B I D A D D E N D U M 0 3

ARDEN HILL - MAIN BUILDING ADDITIONS AND ALTERATIONS
ORANGE-ULSTER BOCES

BID ADDENDUM #3

Sheet Title
GYMNASIUM SILL DETAILS AND INTERIOR FINISHES

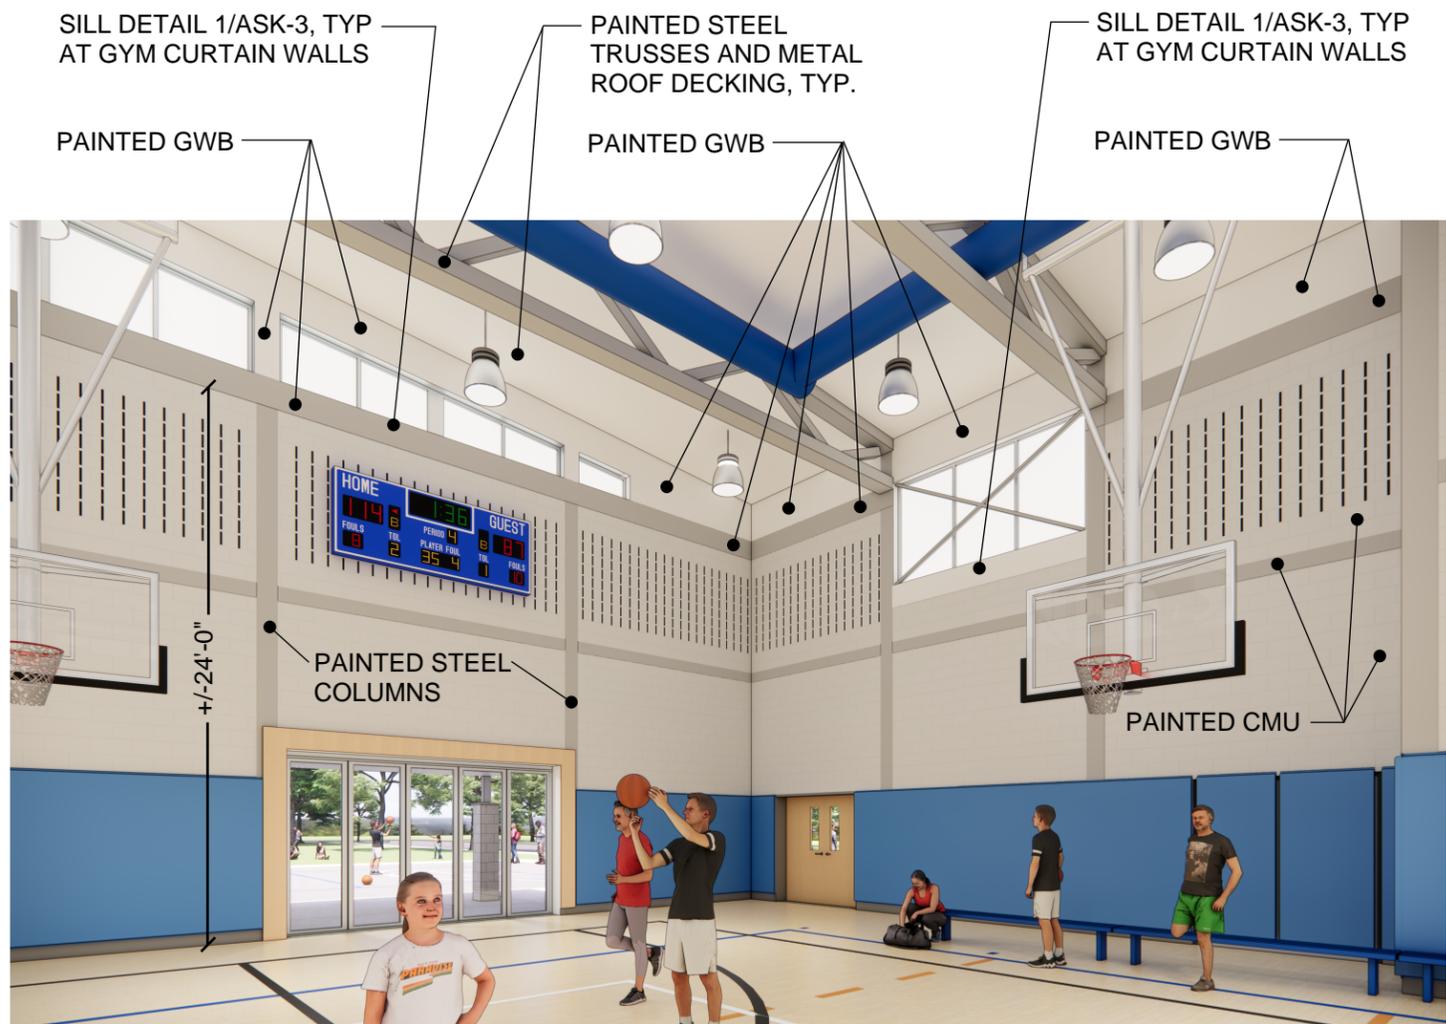
- 7.3 **RFI Question** – Spec section 116843 includes shot clocks - these are not shown on the drawings. Please confirm quantity/location.
RFI Response – There shall be two (2) shot clocks in this project. One on the East gym wall, and one on the West gym wall. Shot clocks shall be installed at 10' AFF. Extend (2) #12 THHN, #12 Ground, in 3/4" EMT from scoreboard circuit (LP-G-28) to power each shot clock.

Sheet No.
ASK-3

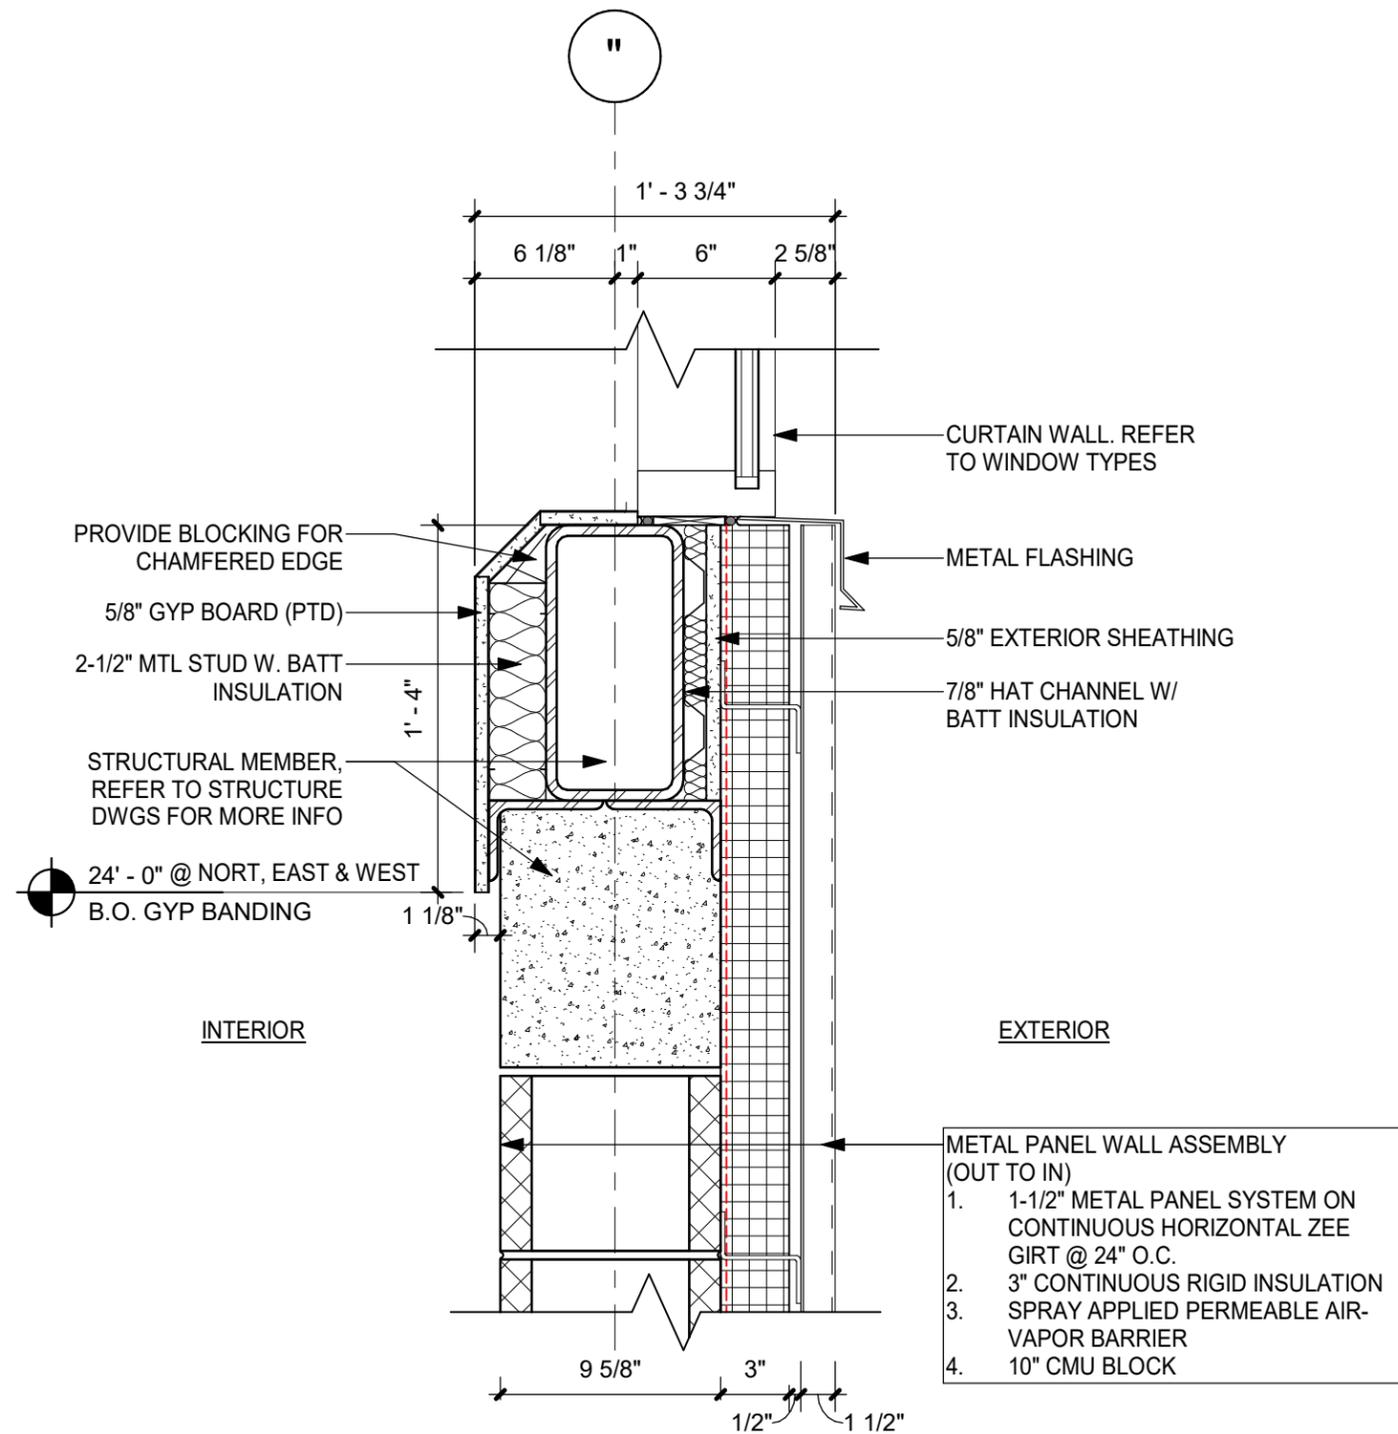
- 7.5 **RFI Question** – Please confirm whether the interior columns in the gymnasium are exposed and painted or if they are all enclosed with GWB column covers.
RFI Response – Columns in Gymnasium G105 are exposed and painted up until approximately 24'-0" A.F.F. From elevation 24'-0" A.F.F. up to underside of decking, provide painted GWB wall covering, furring, and column/steel enclosures per details 1,2&3/A801; 1/A802; 3,8&9/A810; 3&4/A831. See also ASK-3 for additional clarifications on Gym finishes.

- 7.6 **RFI Question** – Drawing 2/A801 calls for chamfer CMU at the interior window sill but the drawings indicated otherwise. Please advise.
RFI Response – CMU sill shall be chamfered at Detail 1/A805 and 5/A811. See attached ASK-3 with enlarged sill details at Gymnasium Windows for additional clarification of sheetrock sills at these areas.
